Subject: LaSalle County Station Unit 1
Proposed Spent Fuel Pool Rerack Amendment
NRC Docket 50-373

Reference: September 30, 1992 B.L. Siegel letter to T.J. Kovach,
Request for Additional Information (RAI), LaSalle Station,
Unit 1 spent Fuel Pool Rerack

ATTACHMENT

FIGURE 1

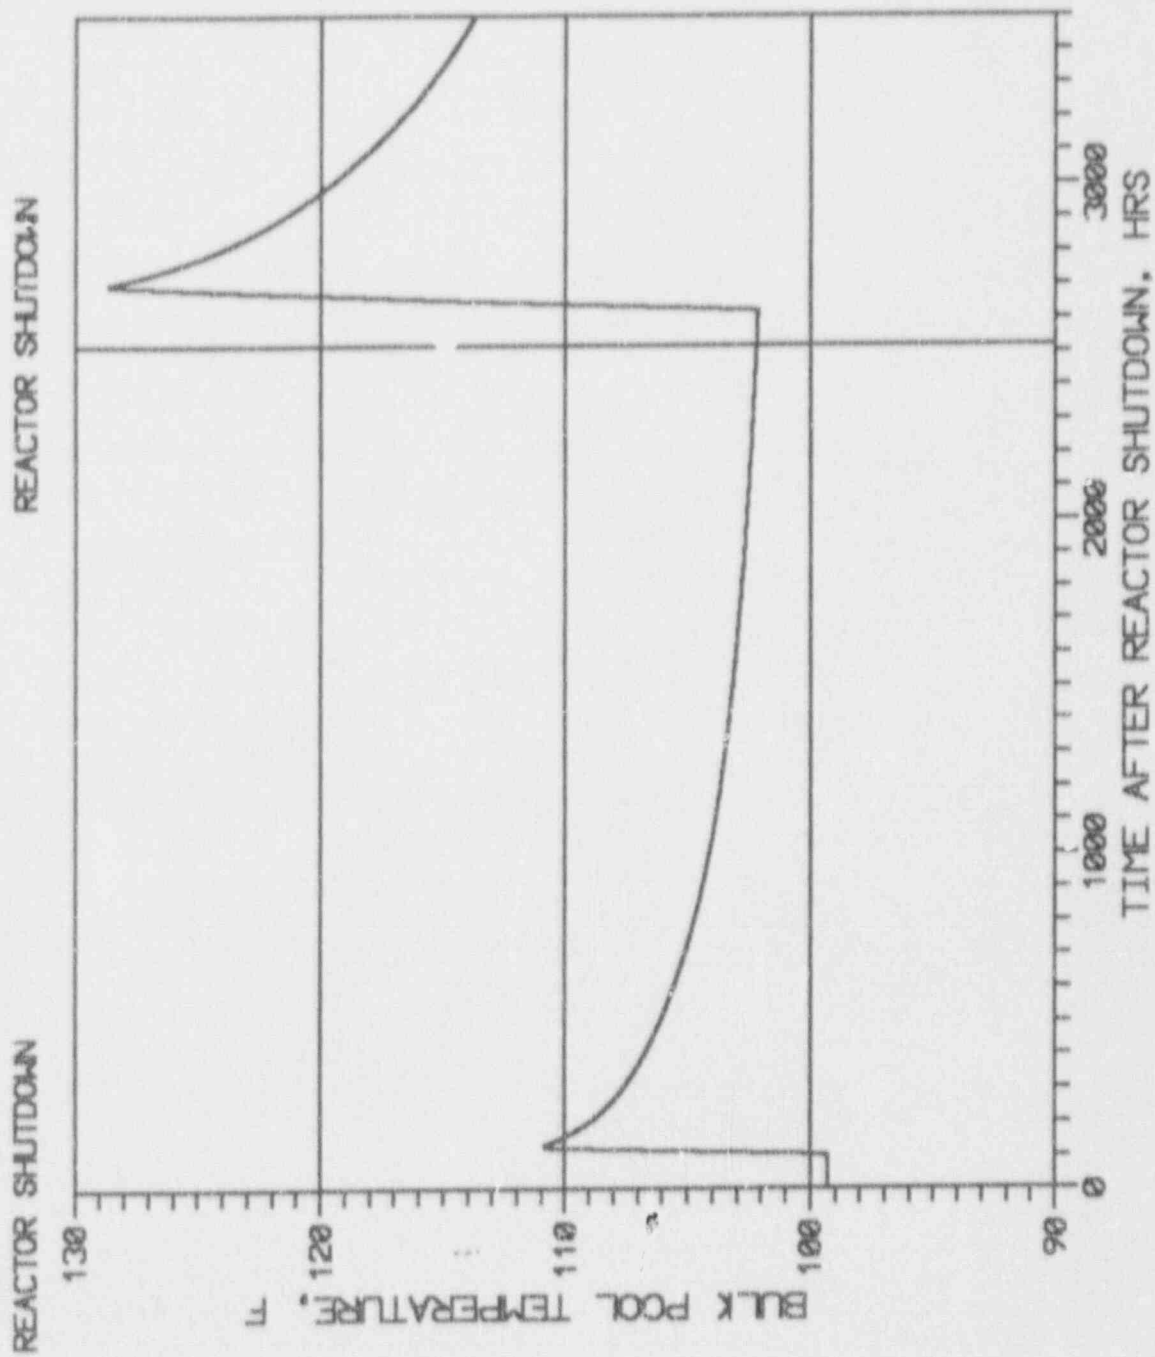
In discussing your calculations relating to bulk pool coolant temperatures (page 5-12) you note that system calculations indicate a total system flow rate of 5050 gpm in lieu of the 6000 gpm anticipated by Table 9.1-3 of the UFSAR. Discuss these results and show how you arrive at your estimate that such flow decrease will result in a bulk coolant temperature increase of less than 12°F.

The estimated upper bound on the expected temperature increase was based on previous experience of Holtec engineers with such analyses. To respond to this question, a rigorous calculation has been performed to obtain the pool temperature profile for the case of 5050 gpm spent fuel water rate. In order to perform this analysis the temperature effectiveness of the fuel pool heat exchanger for the reduced flow scenario had to be calculated. Calculations show that the effectiveness of cooler drops from 0.292 to 0.279 when the flow rate is reduced from 6000 gpm to 5050 gpm. ONEPOOL was utilized to determine the pool water temperature profile for Case II in Table 5.8.2 (the governing case). The temperature profile is shown in Figure 1, which indicates that the maximum pool water temperature is 128.6°F. Thus, the actual increase is only 1.4°F (128.6°F minus 127.2°F), which is conservatively bounded by the estimate of 12°F presented in the licensing report.
